LOT 355 RED GUM PASS ROAD, KENDENUP –
CARAVAN PARK

Location Plan
Lot 355 Site Plan
Caravan Stay Site Plan
Summary of Submissions

Meeting Date: 23 March 2021

Summary of Submissions
Lot 355 Red Gum Pass Road
Caravan Park in Rural Zone

CARAVAN STAY SITE PLAN
 SCALE 1:500

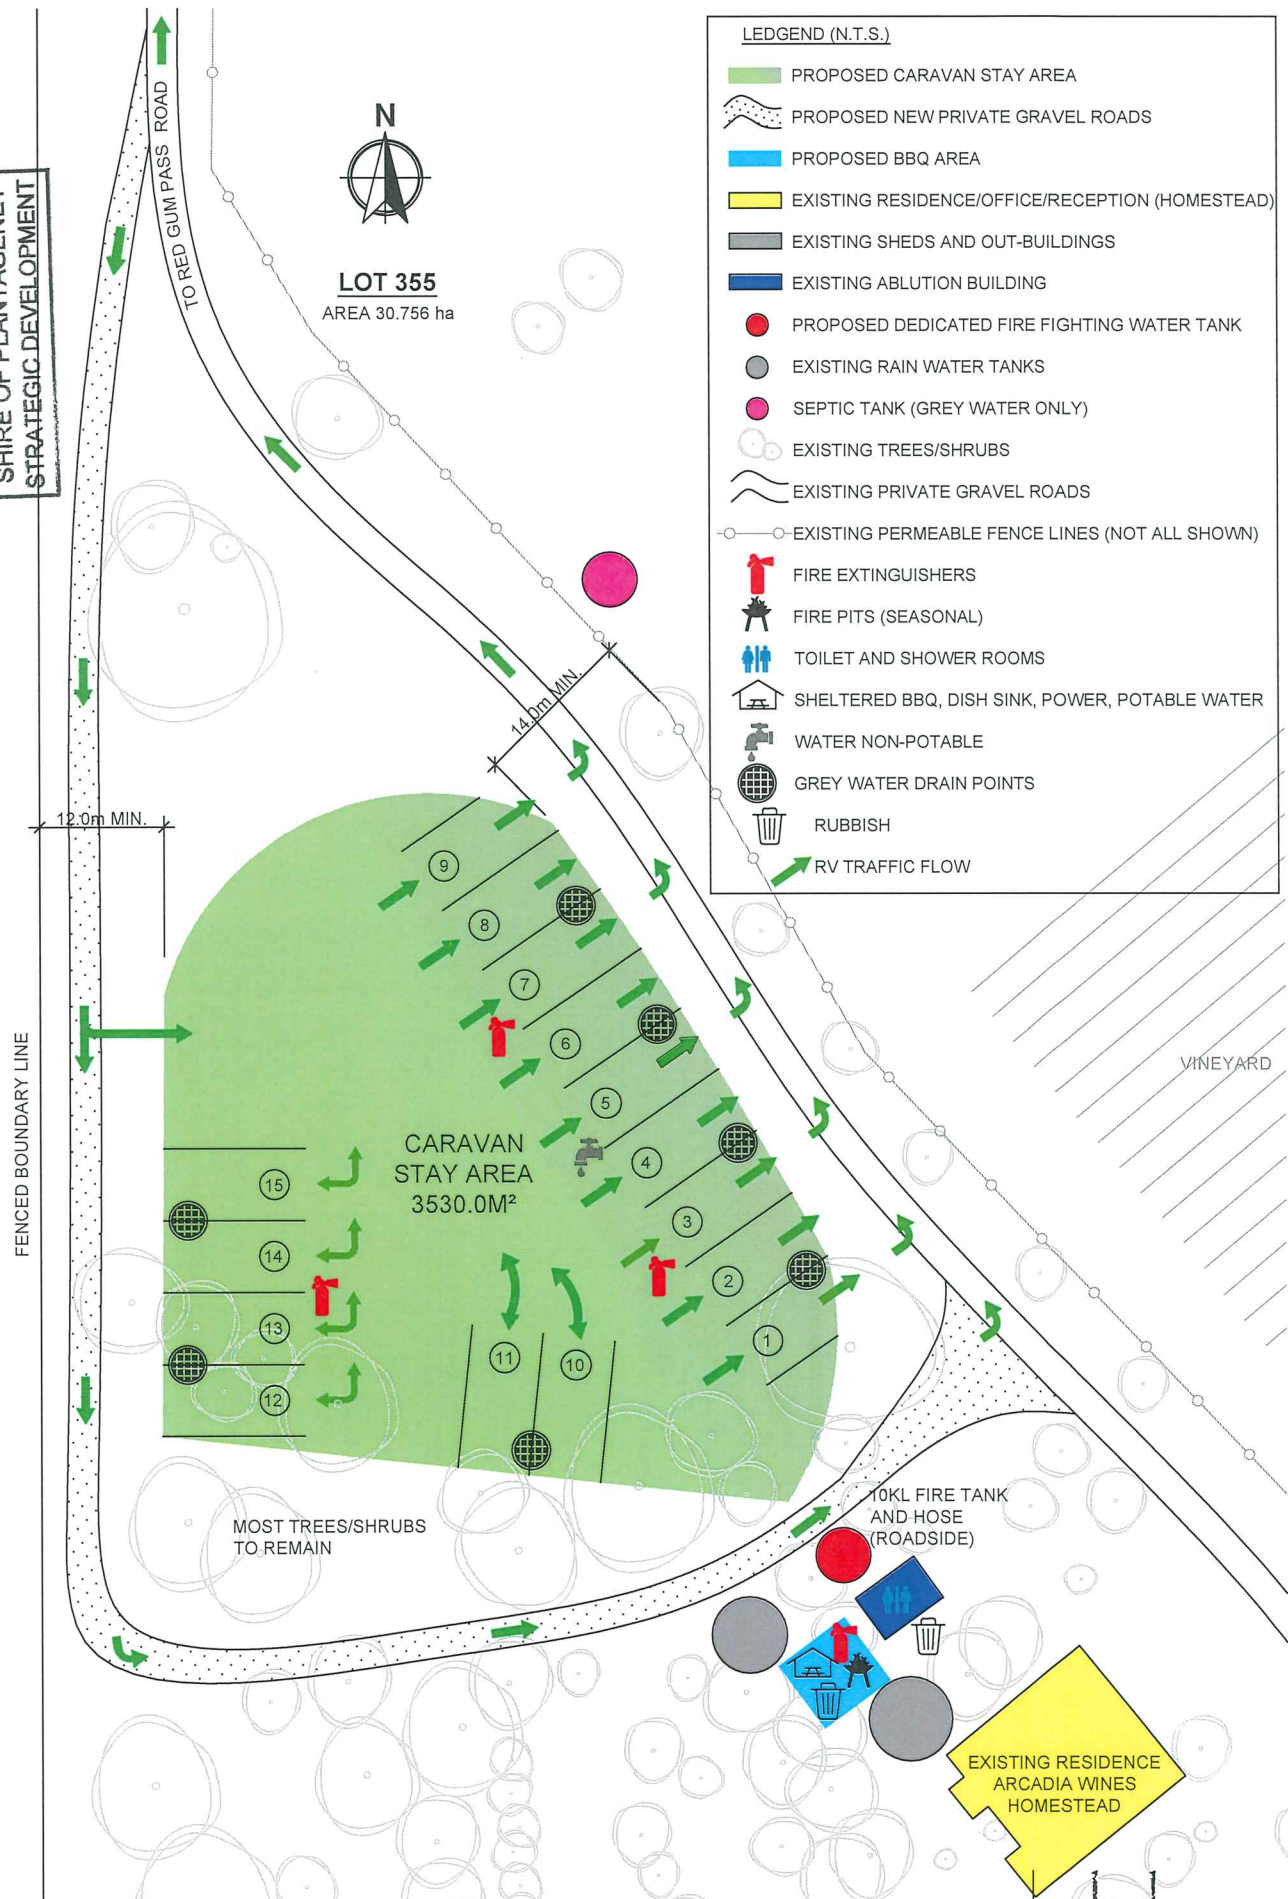
<p>Vegetation classification</p>		<p>Aerial imagery and the photography provided does not validate that the proposed asset protection zone (APZ) is currently compliant with Schedule 1 of the Guidelines. Notably, vegetation is in close proximity to buildings and tree canopies less than 5 m apart. The Caravan Stay Site Plan (DRG. NO. A-2 rev B) states that 'most trees/shrubs to remain'. The BMP states that no vegetation will be removed. It is unclear what extent of vegetation removal or modification is required, the timing of the management action, or who will undertake the action. To remove ambiguity for the landowner and to provide a compliance mechanism, Figure 9 of the BMP should be modified to identify the location of vegetation to be removed or modified to establish a compliant APZ or a standalone Clearing Plan be prepared.</p>	<p>Modification to the BMP is required.</p>
<p>Vegetation removal to establish the APZ</p>			<p>Modification to the BMP is required.</p>
